APPEAL SUMMARY

Appeal ID: 18786	Project Address: 1310 NW Johnson St
Hearing Date: 12/19/18	Appellant Name: Eric Li
Case No.: B-011	Appellant Phone: 5032200668
Appeal Type: Building	Plans Examiner/Inspector: John Cooley
Project Type: commercial	Stories: 7 Occupancy: R-2, M Construction Type: 3-B, 1-A
Building/Business Name: The Pearl Apartments	Fire Sprinklers: Yes - Full Coverage
Appeal Involves: Erection of a new structure	LUR or Permit Application No.: 18-244022-CO
Plan Submitted Option: pdf [File 1] [File 2] [File 3] [File 4] [File 5]	Proposed use: Mixed Use Residential and Retail

APPEAL INFORMATION SHEET

PEARL APARTMENTS
 Portland Oregon
 FHA PROJECT NUMBER:
 126-35329

EXTERIOR ELEVATIONS & WINDOW TYPES

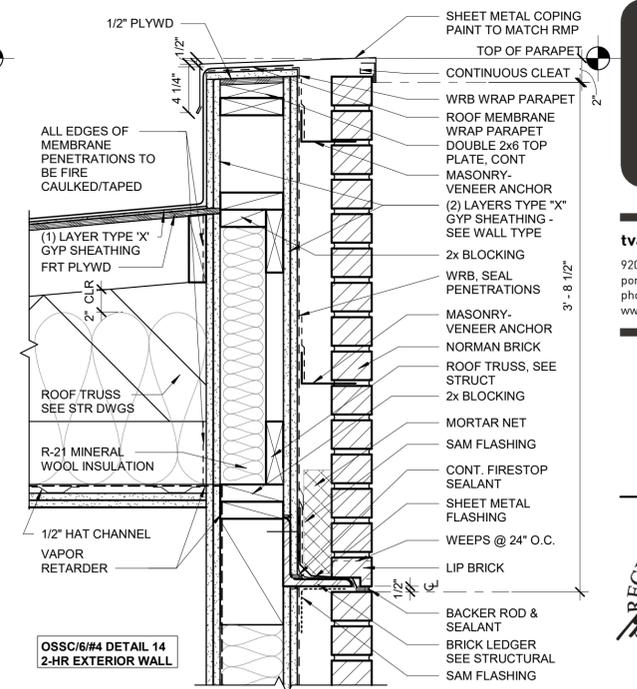
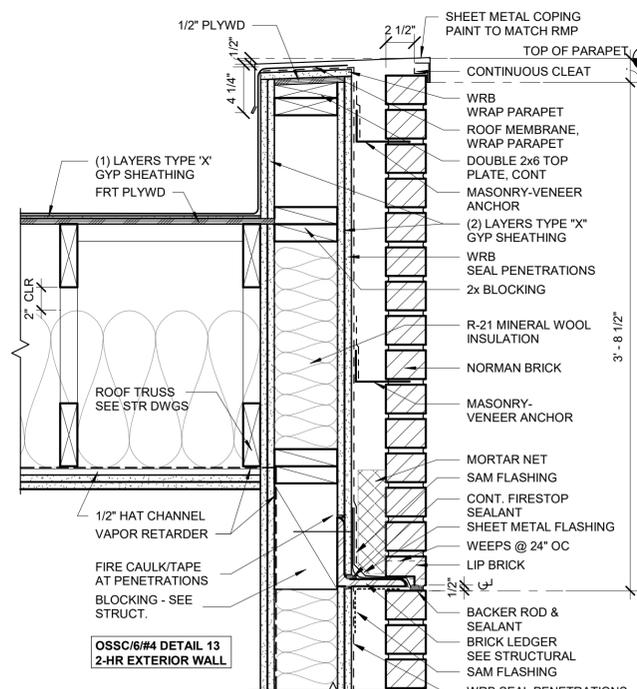
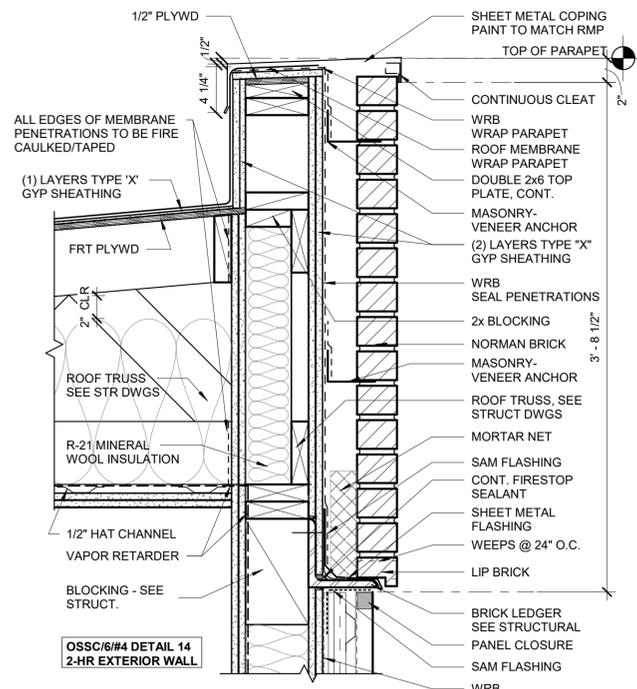
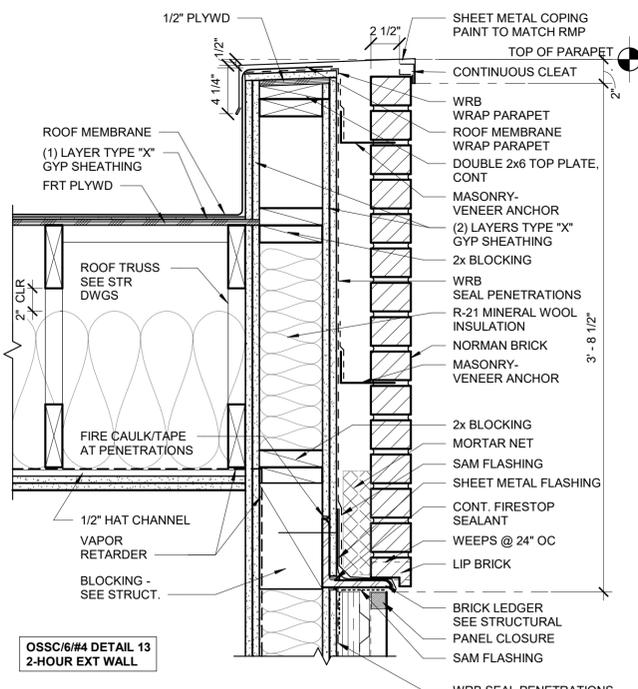
ITEM #2: Joe Cooley, fire life safety plans examiner from the City of Portland has produced a checklist comment #9 stating that exterior windows located 0' to 15' above roofs of adjacent buildings that are less than 15' away are required to have a 3/4- Rating. A proposed design solution to this condition is to fix in place two of the windows, and to, and for all windows within 10'-15' both horizontally and vertically of the adjacent roof to be provided with sprinklers per ICC NER-516 and OSSC 705.8.6.2 for a 3/4 hour rating.

The affixing of the fourth floor windows and sprinkler system protection on the north elevation is a direct response in coordination with John Cooley, to bring the building into compliance with 705.8.6.2. All other windows have operable portions to comply with OSSC/6/#4. This will prevent the spread of flames from the adjacent building to open windows on this project.

2. Type 13 water curtain sprinkler protection at non-fire rated openings in buildings with vertical exposure on separate lots: Hold for additional information.

EXTERIOR DETAILS

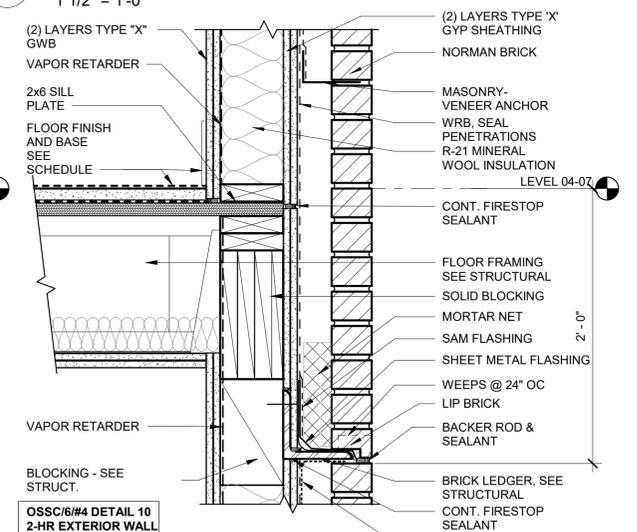
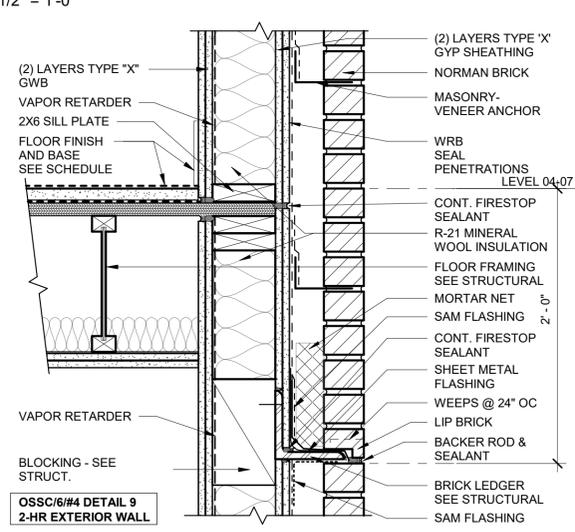
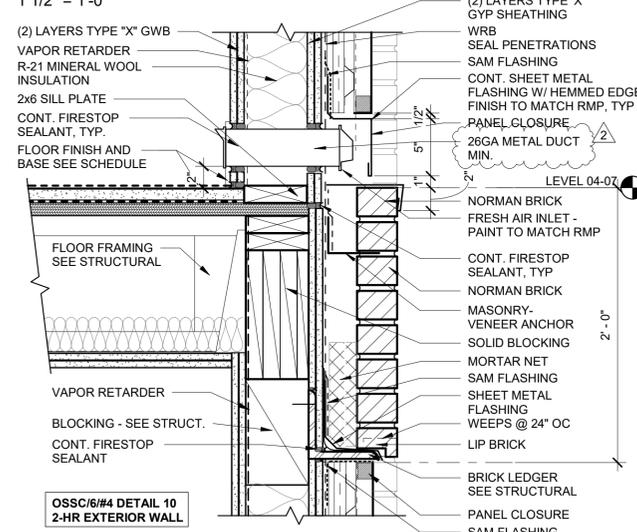
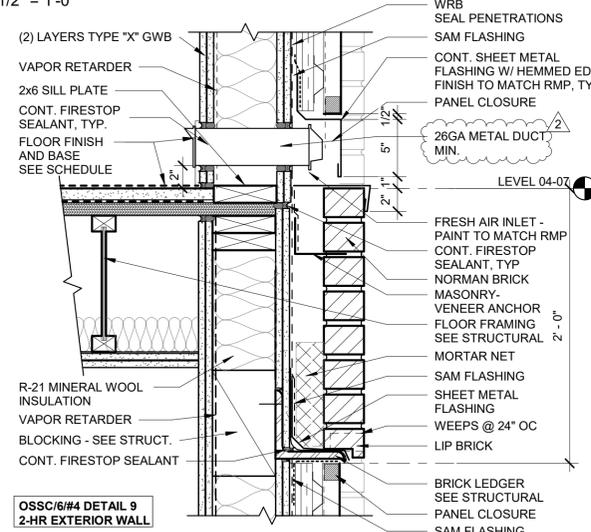
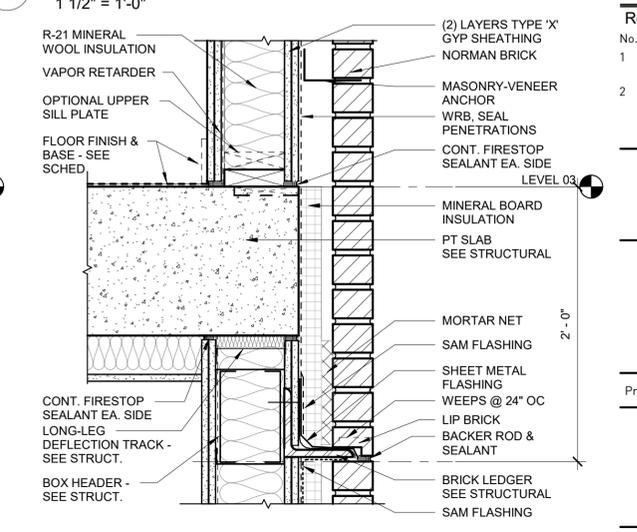
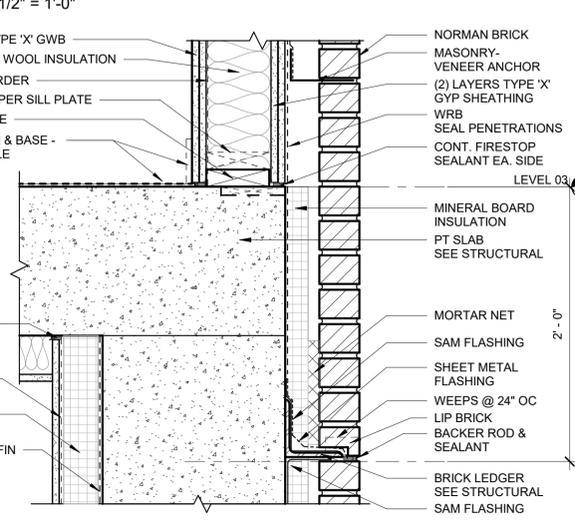
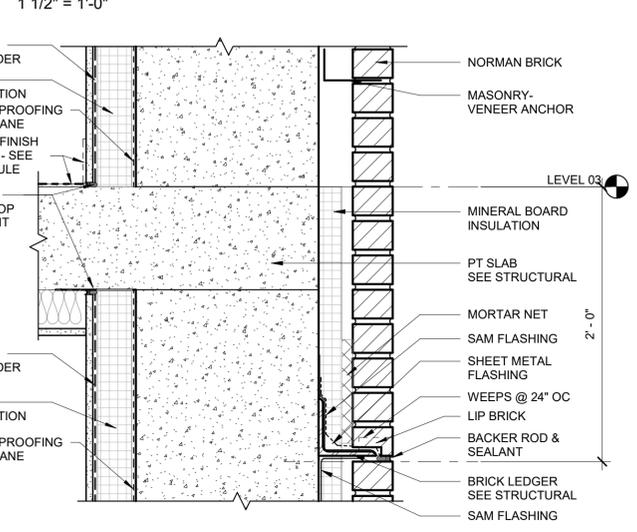
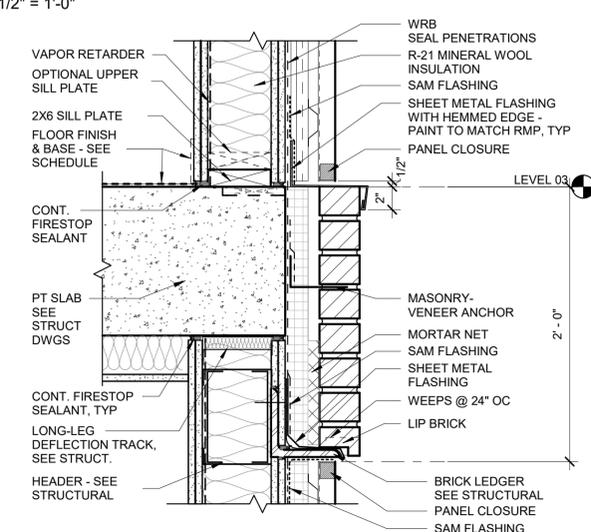
Details 8 and 11 on A8.01.
